LAND USE APPLICATION

Other: Modification

NARRATIVE & COMPLIANCE REPORT

Sunset View at West Banks: Minor Modification

PCD
 PACIFIC COMMUNITY DESIGN
 12564 SW MAIN STREET
 TIGARD, OR 97223
 (503) 941-9484
 JOB NO. 130-004
 SHEET 2 OF 6

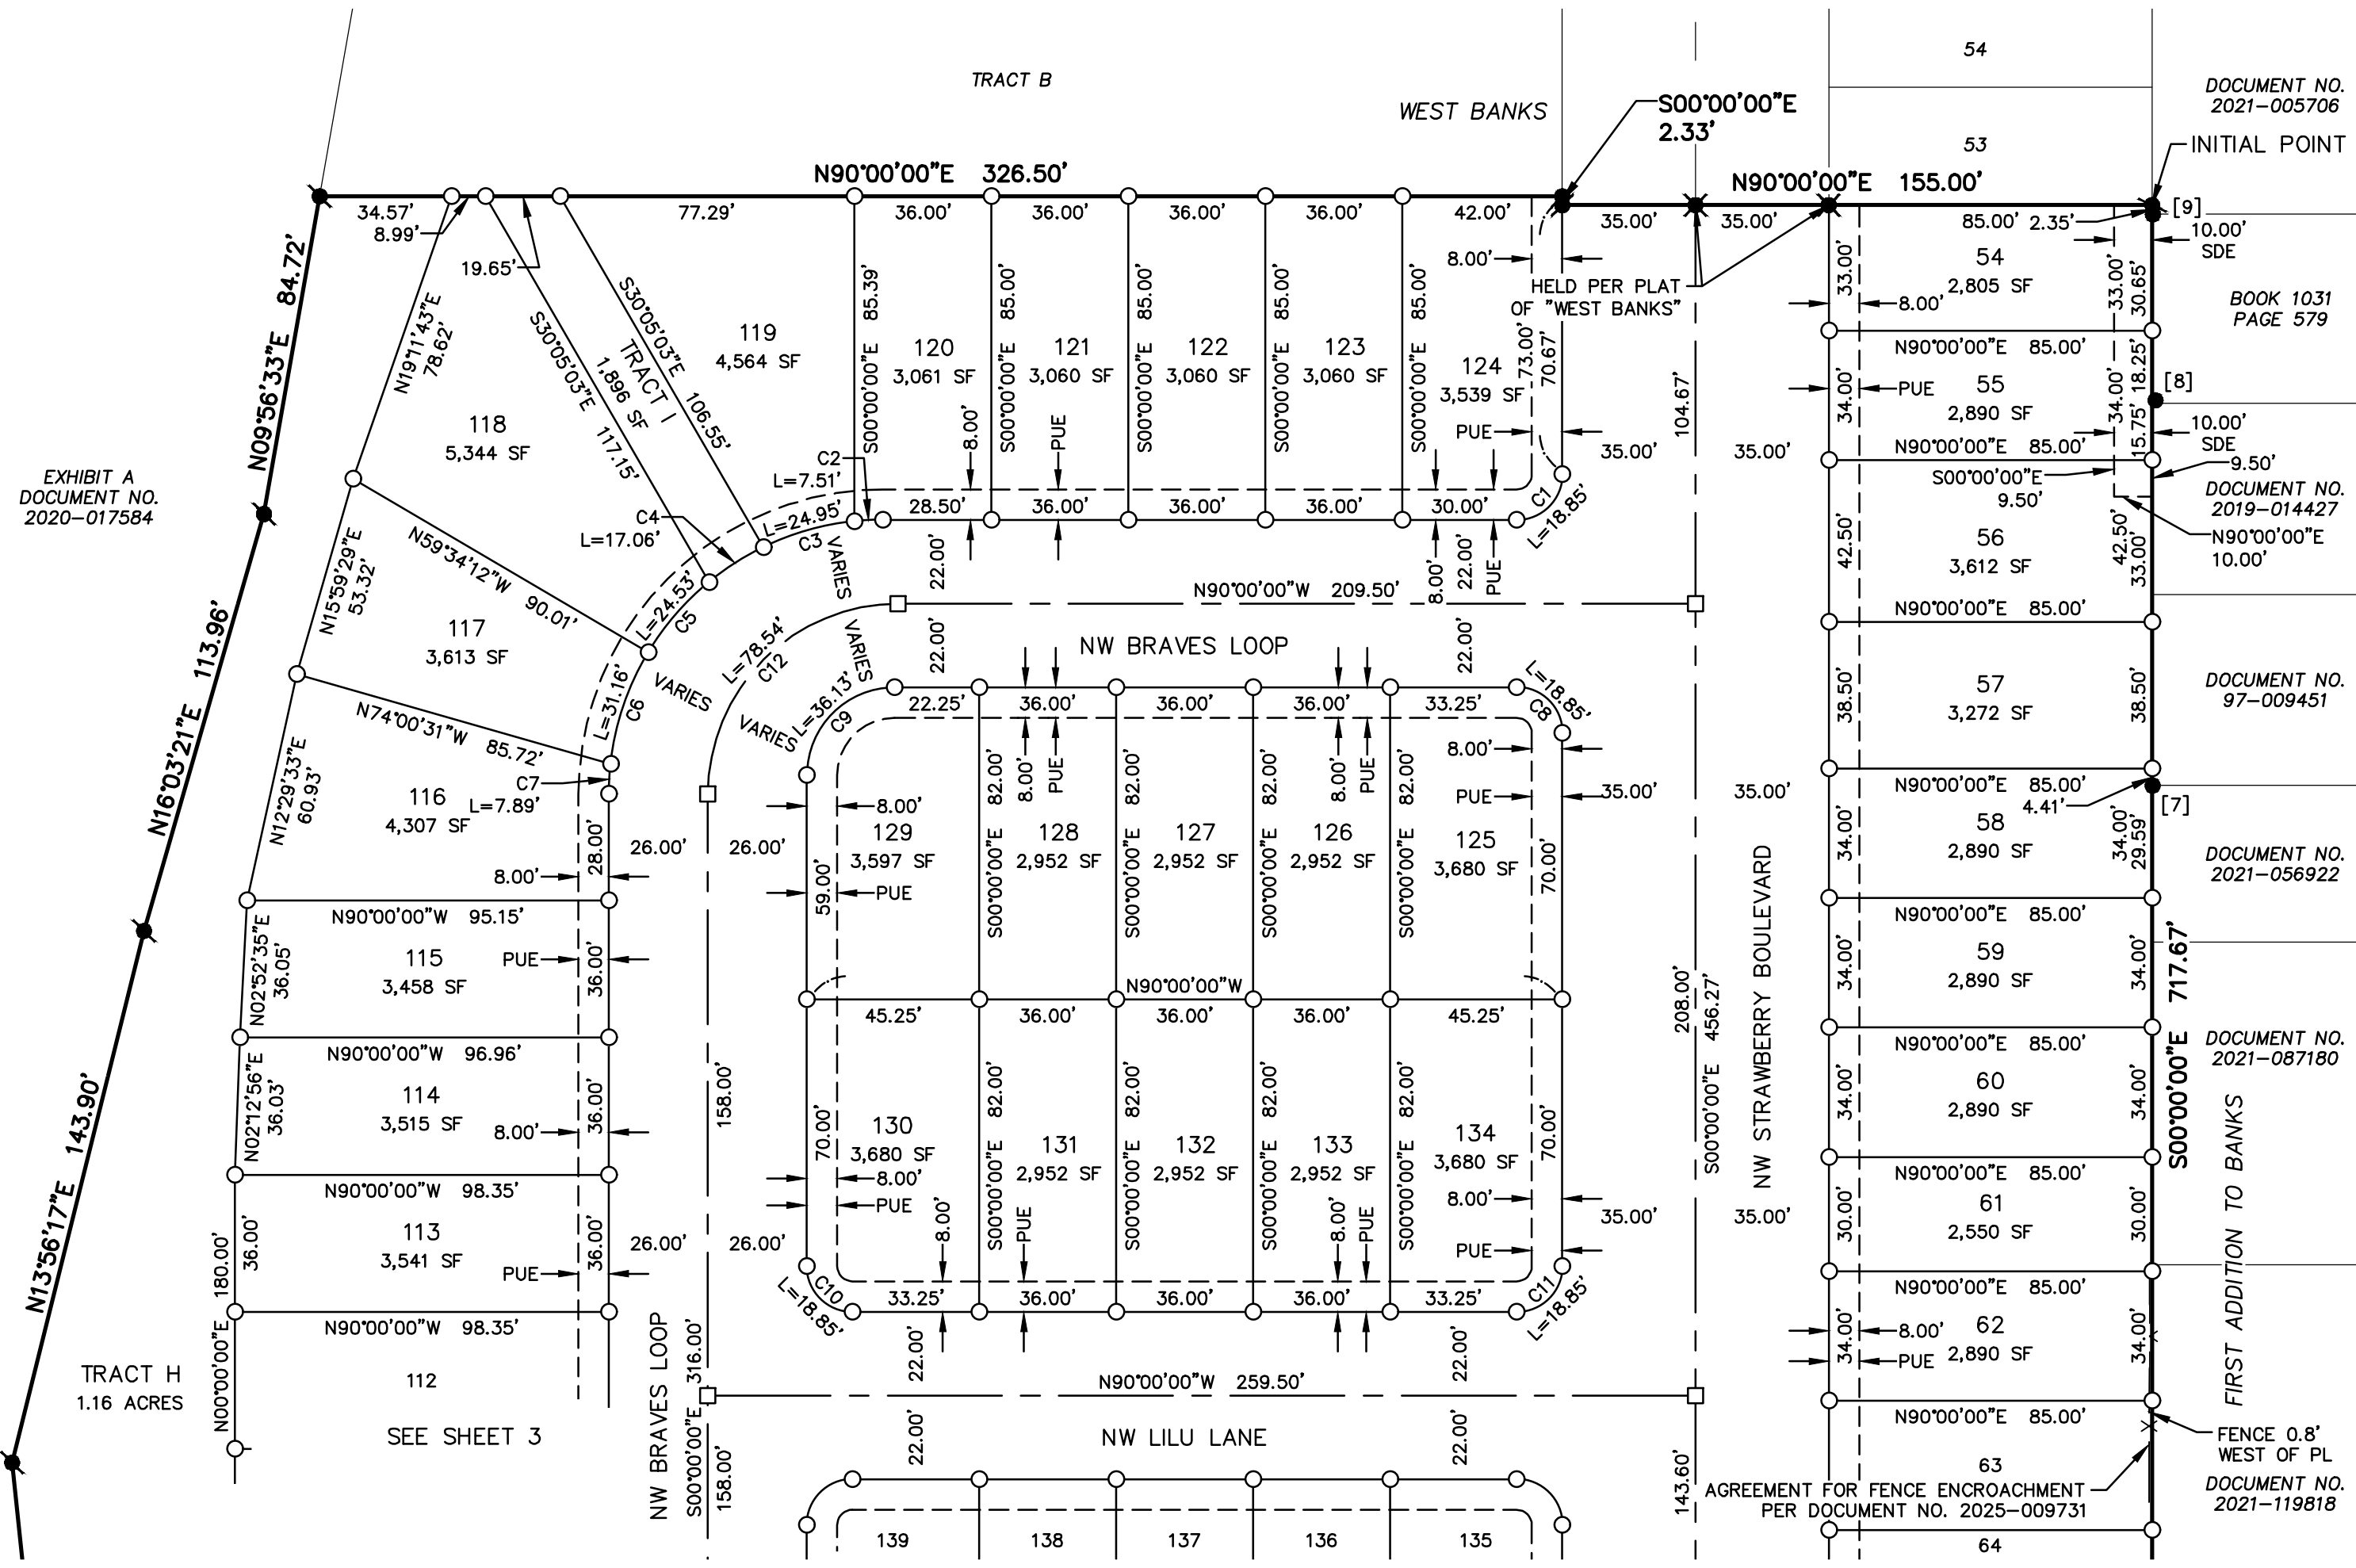
Also included with this Minor Modification application is the removal of Tract E, between lots 56 and 57. The city requested on March 13th that this tract, which held a pedestrian path, be removed. This was originally Tract C in the Master Planned Development application. The Tract E area has been absorbed and distributed to lots 56 and 57. Sheet 2 in Exhibit B details the tract removal and lot size changes due to this requested change.

Response: This minor modification application includes the removal of Tract E, which was a pedestrian path included in the open space calculation for the development. However, even with the removal of the 1,445 square feet of this tract, the development is still able to provide approximately 3 acres of open space. The remaining public benefits provided with the approved Master Planned development application are still provided with this modification- parks and trail space as identified in the Banks Parks and Recreation Master Plan, transportation improvements as identified in the City's TSP, and a greater variety of housing types and lot sizes. The park and trail will be dedicated to and maintained by the city. The project continues to meet this criteria by providing a minimum of approximately 20% open space.

Response: The city has requested that Tract E, between lots 56 and 57, be removed and the tract area be absorbed and distributed between the two lots. Therefore, this condition is no longer applicable.
